Lower Hill Redevelopment

First Amendment to Preliminary Land Development Plan

Pittsburgh Arena Real Estate Redevelopment LP
July 25, 2022
Revised: November 4, 2022

Amendment to Section 1: Introduction & Section 2: Regulating Plans

Figure 2.25 Accessible Streets Diagram

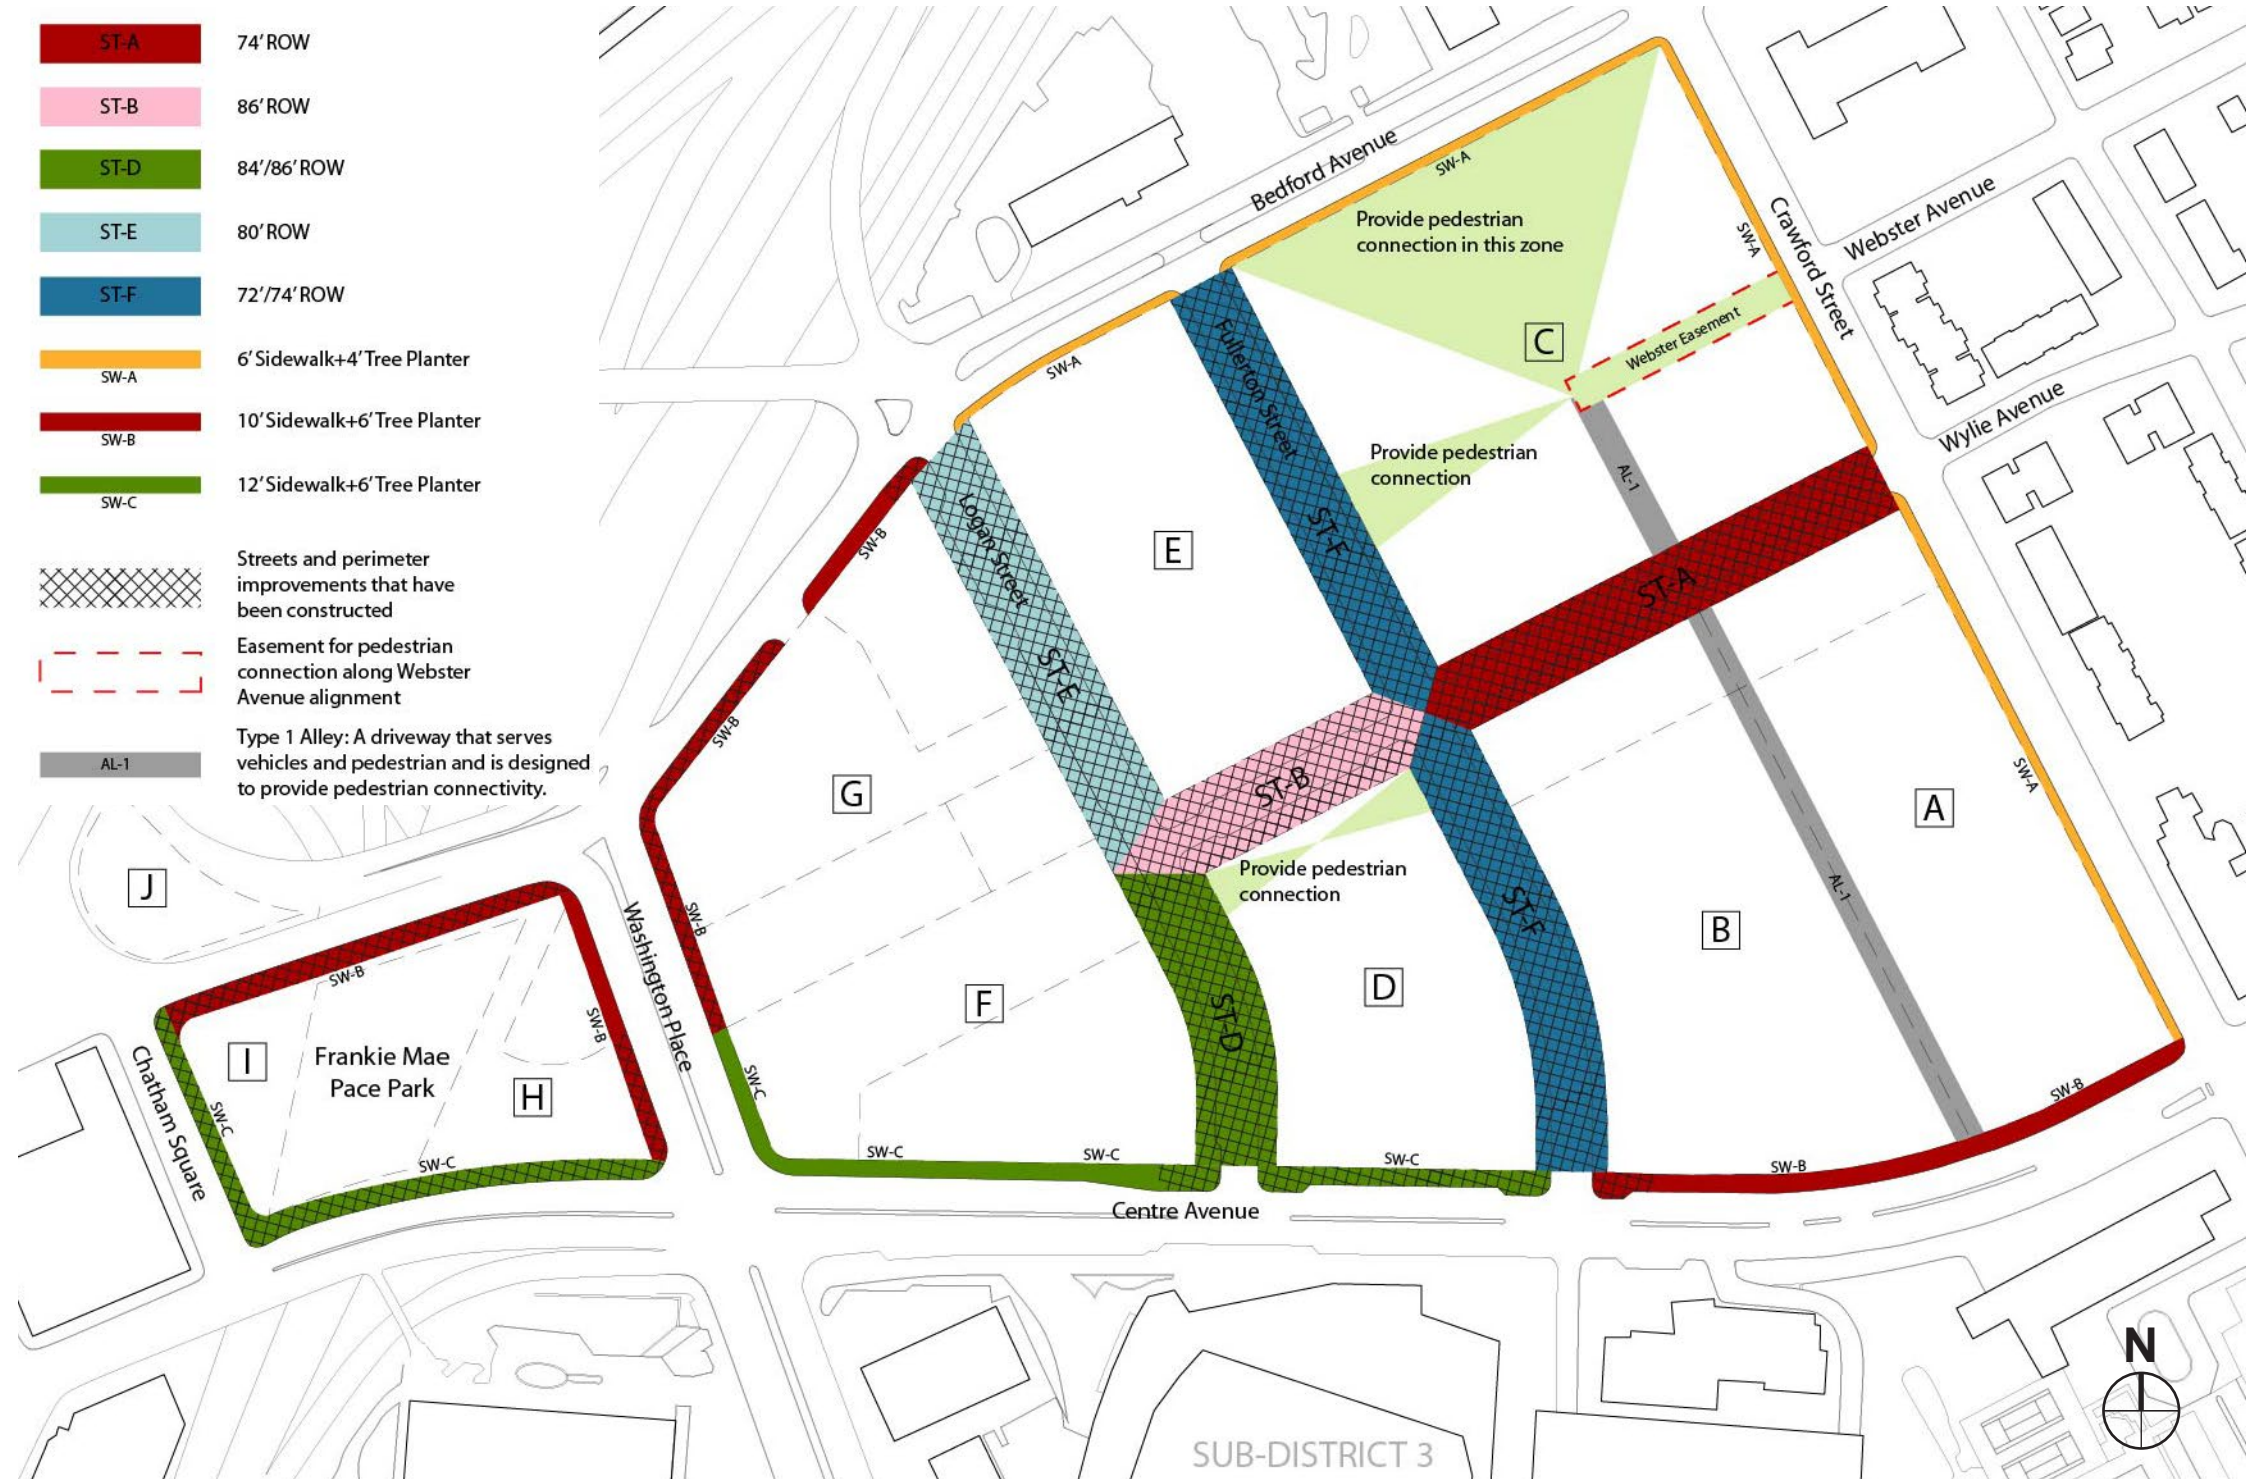
Figures 2.25 and 2.26 are revised to reflect the Block revisions identified in Section 2.4 and as follows:

Blocks A, B and C are modified, the required easement aligning with Webster Street is retained. Pedestrian connection zones are retained and modified in Blocks A, B and C. Pedestrian connection zones are added in Block D.

Updates to Figure 2.25 Accessible Streets Diagram (Shown below) and Figure 2.26 Street and Connections Regulating Plan (Shown right)

Updates to Figure 2.43 and 2.44 (Shown right)

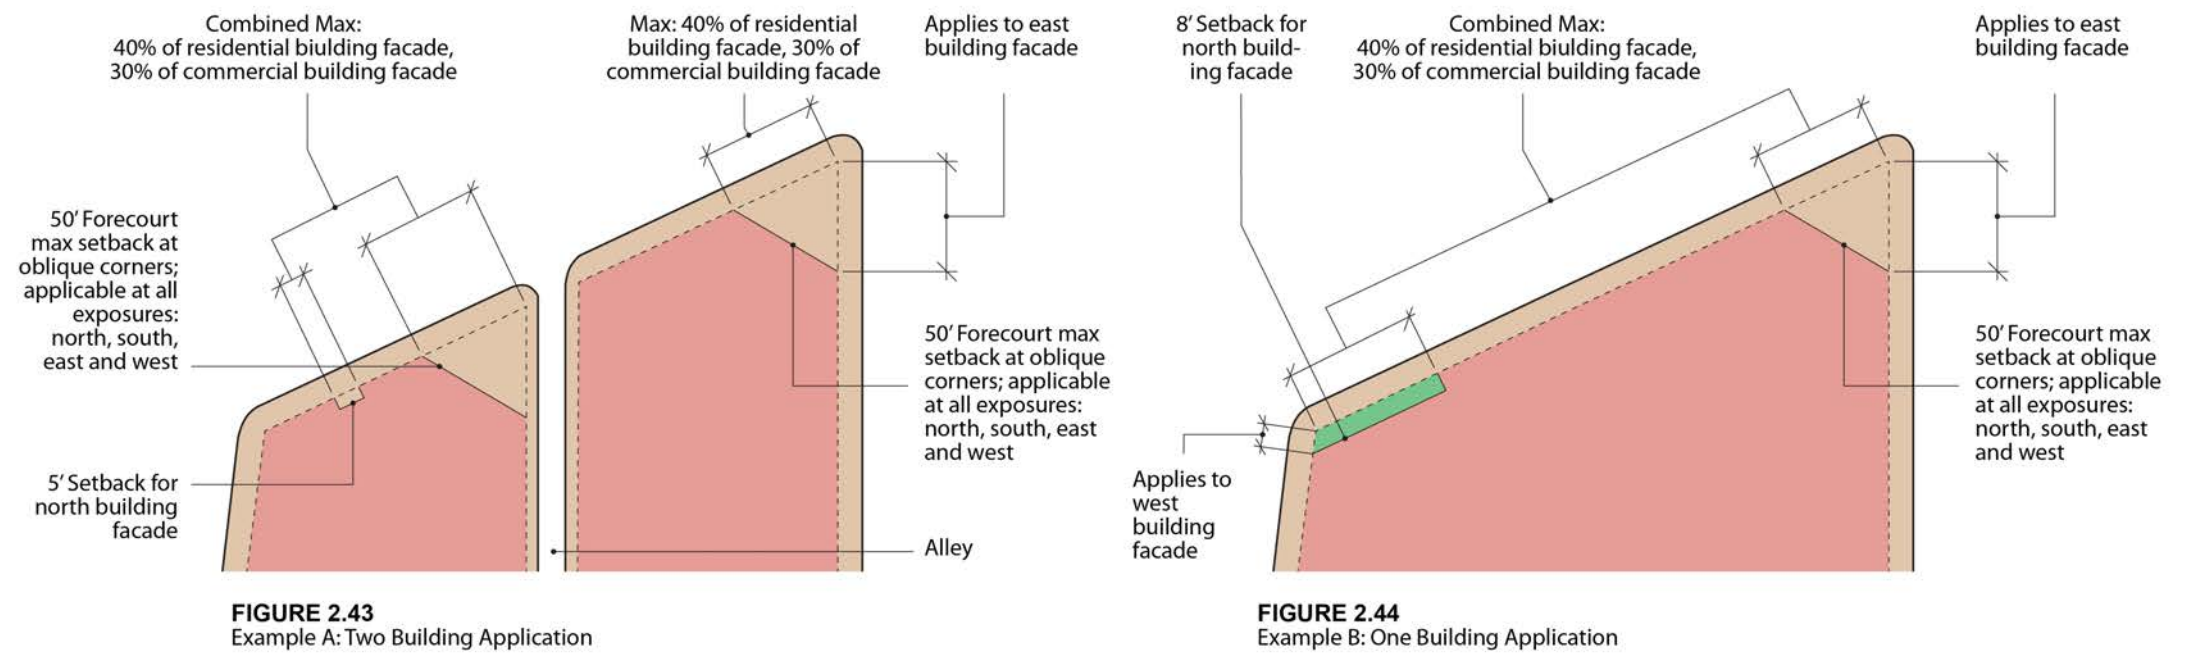
2.7.2 Frontage Type Applications
Figures 2.43 and 2.44 are revised to increase the allowable Forecourt setback at oblique corners to 50' for commercial buildings, matching the dimension provided for residential buildings. The dimension is clarified to be applicable at all exposures; north, south, east and west.

Figure 2.59 Minimum height requirement diagram

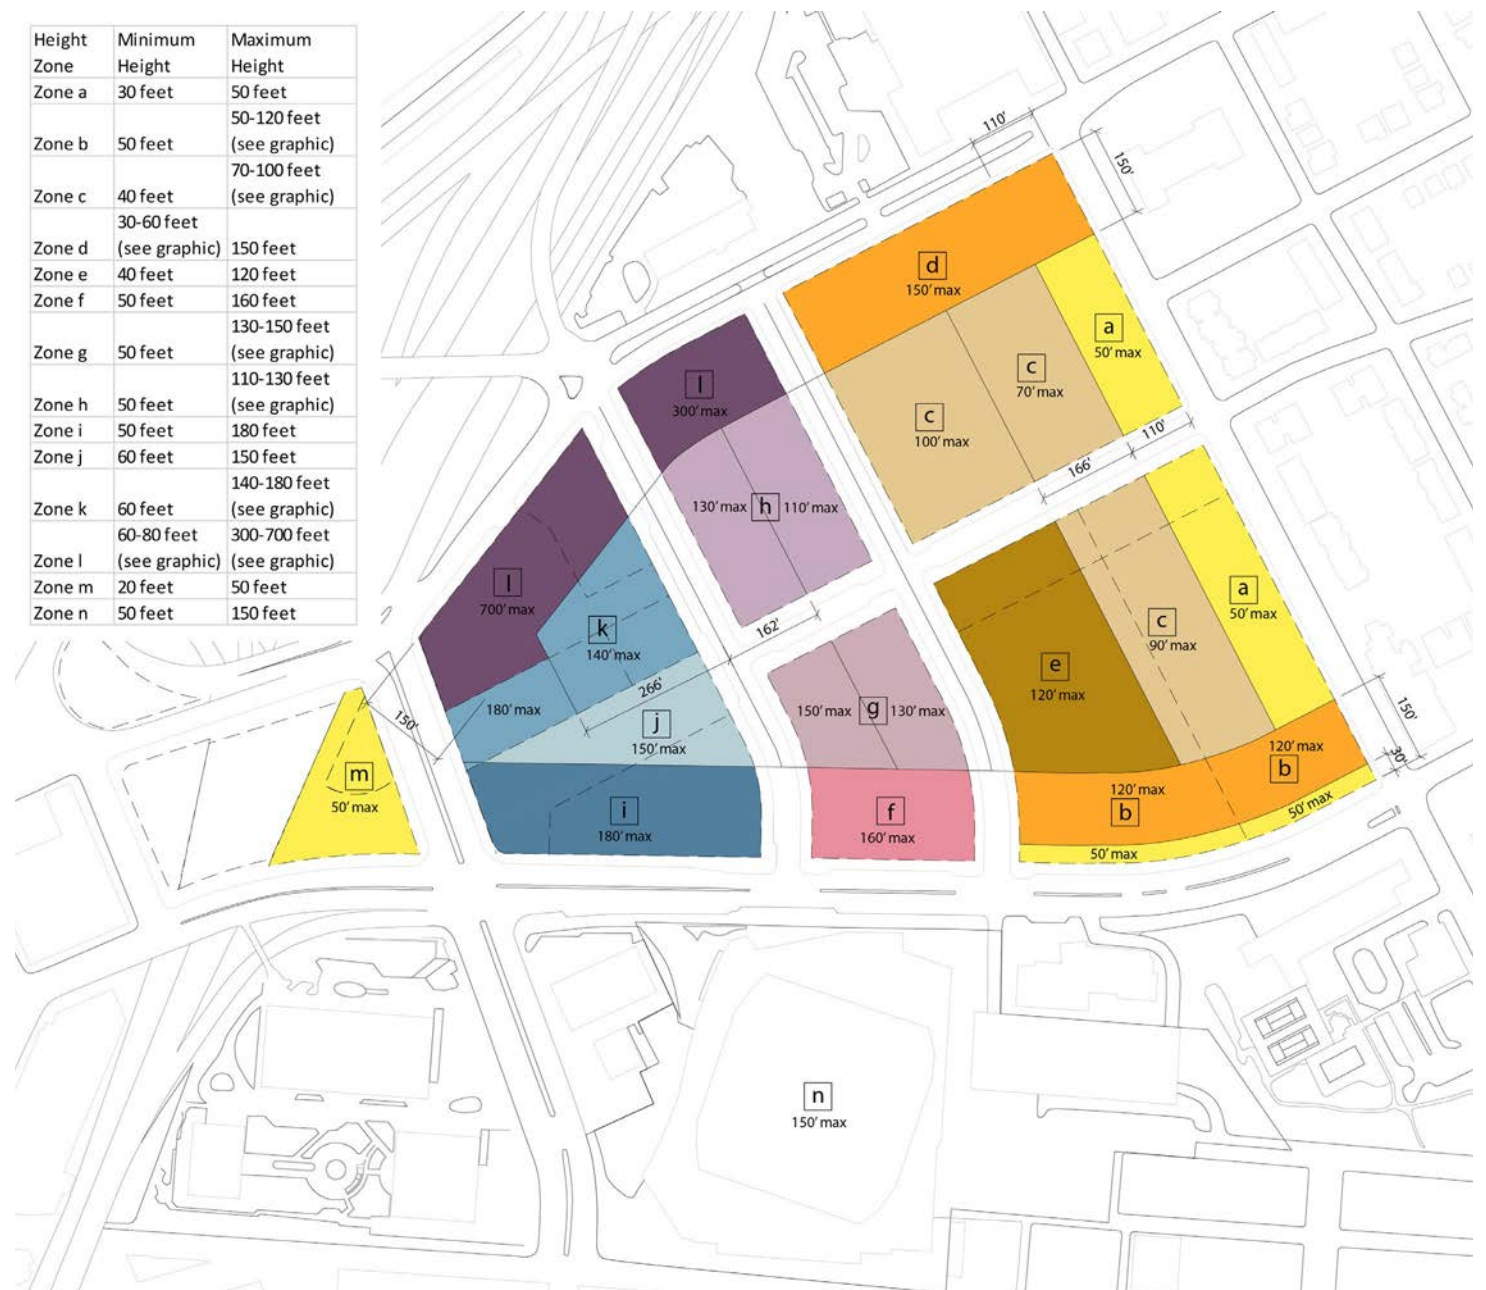
Figures 2.59 and 2.60 are revised to reflect the Block revisions identified in Section 2.4. Height Zones b, d, h, i and l are revised to correct discrepancies, these shall follow the criteria established in the SP-11 Lower Hill, Section 909.01.R.5(c), Height Standards.

Figure 2.66 Parking and Service Regulating Plan

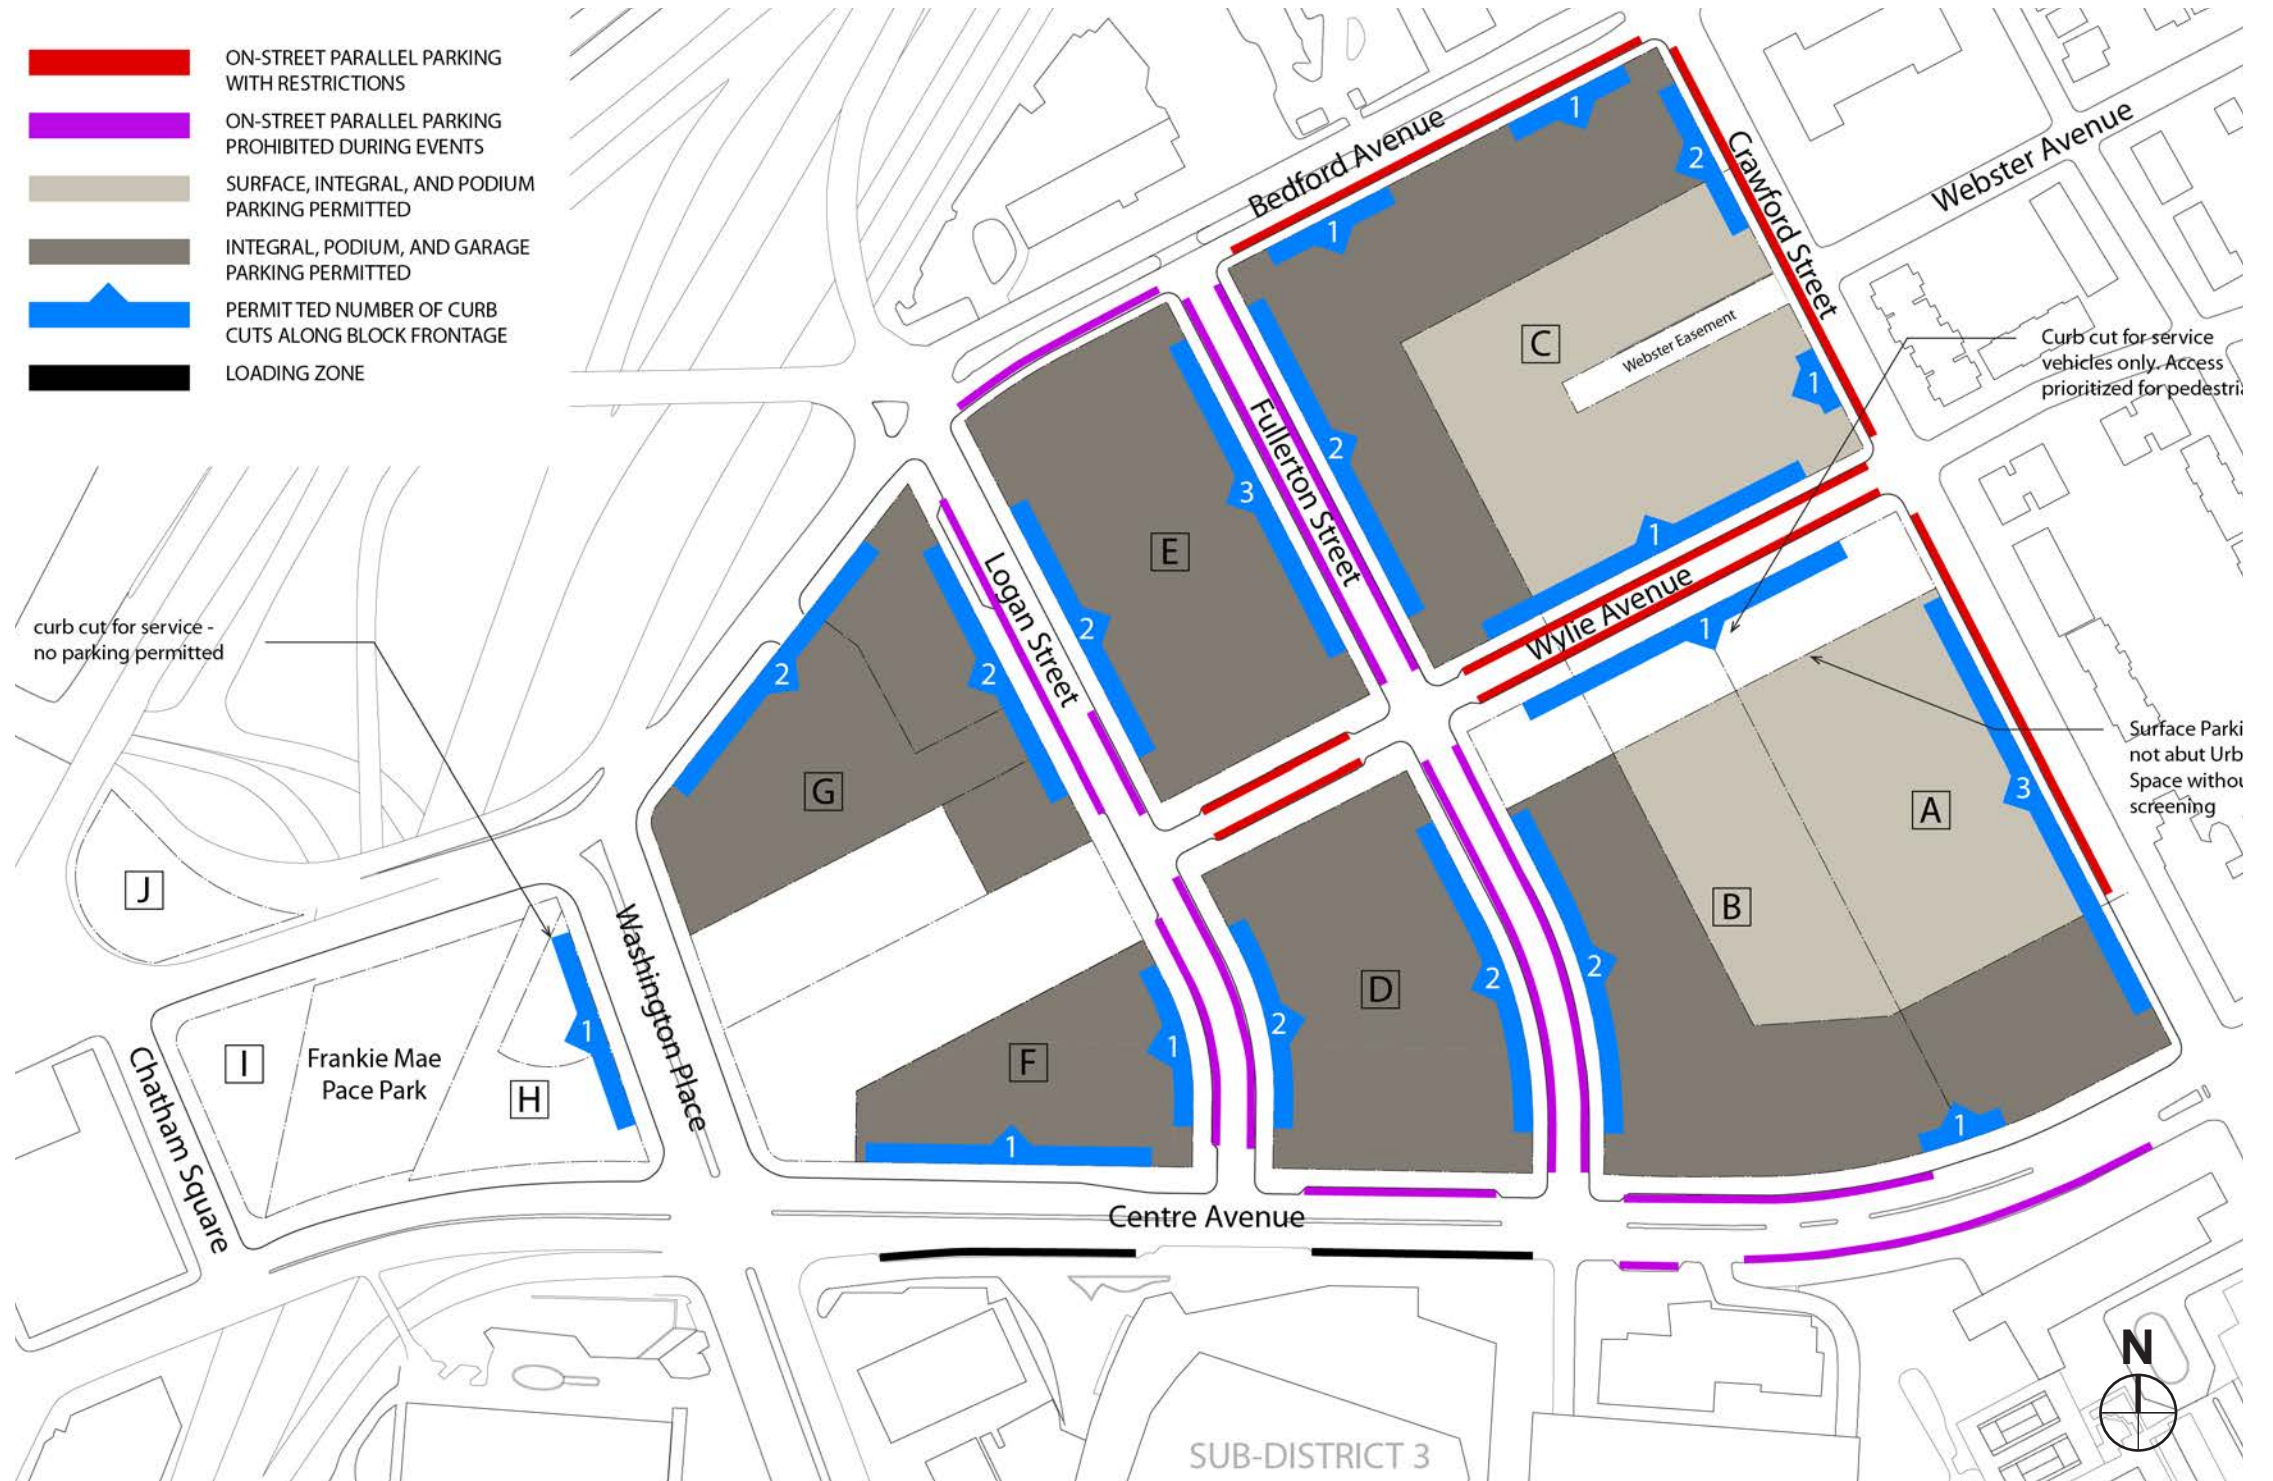
Figure 2.66 is revised to reflect the Block revisions identified in Section 2.4 and as follows: (1) one curb cut between Block A1 and B1 is permissible along Centre Avenue, (2) Three curb cuts on Block E are permissible along Fullerton Street, (3) one curb cut on Block F is permissible along Centre Avenue. (4) one curb cut on Block H-R is permissible along Washington Place for building services.
